機関室ビルジ排出の  
配管について

# NKテクニカル インフォメーション

No.: 405

Date: 平成13年6月15日

Fig. I

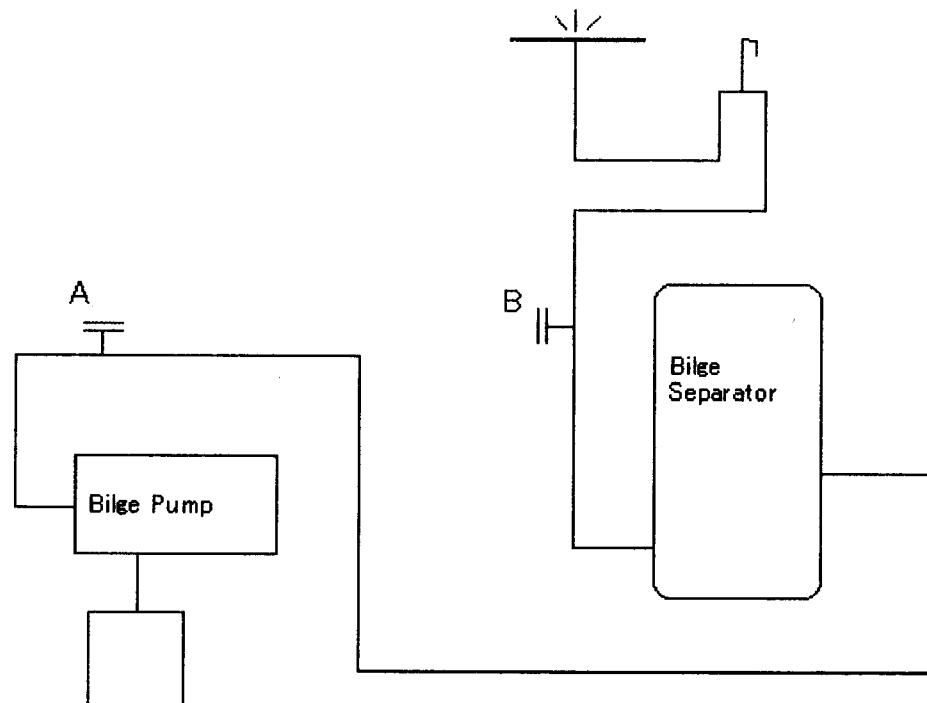
Where both bolted blanked flanges A and B are fitted to the Bilge Discharge Line as shown in Fig. I and II, the flange A should be cropped off or blinded off by welding in order to avoid an unexpected suspicion concerning violations of MARPOL regulations. In this case, the flange B is acceptable only for operation test of the Bilge Separator.

ご存知のとおり、MARPOL 73/78 の規定により機関室のビルジの排出については、油分濃度が 15ppm 以上の油性混合物の排出を禁止しています。更に、総トン数 1 万トン以上の船舶においては、15ppm を超えた場合に警報を発する装置及び排出を確実に自動的に停止される装置が要求されています。従いまして、油水分離器から船外へ排出される配管には、枝管等により乗組員が油水分離器を通さず容易に直接排出できるようないかなる接続も許されておりません。たとえ直接に排出する固定配管が設置されていない場合であっても、排出管の途中で枝管にフランジ等が設置され短管やゴムホース等でビルジポンプの吐出側に接続できるような仮配管は、認められません。但し、通水試験用の枝管が船外排出管側にあり、ビルジポンプ吐出側に接続可能な取付け物がない場合は、認められます。このような疑わしい仮配管がある船舶が、PSC 等により予期しない疑いを受け、船舶の運航に重大な支障を来たし多大な損害を蒙ったケースも報告されております。貴社におかれましては、全管理船舶について調査を行い、もしこのような仮配管の接続により直接ビルジ排出が可能となる疑わしい配管が発見された場合は、恒久的に枝管を撤去されるか、メラフランジを溶接等により固定し使用できないような措置を講じられますようお願い申し上げます。
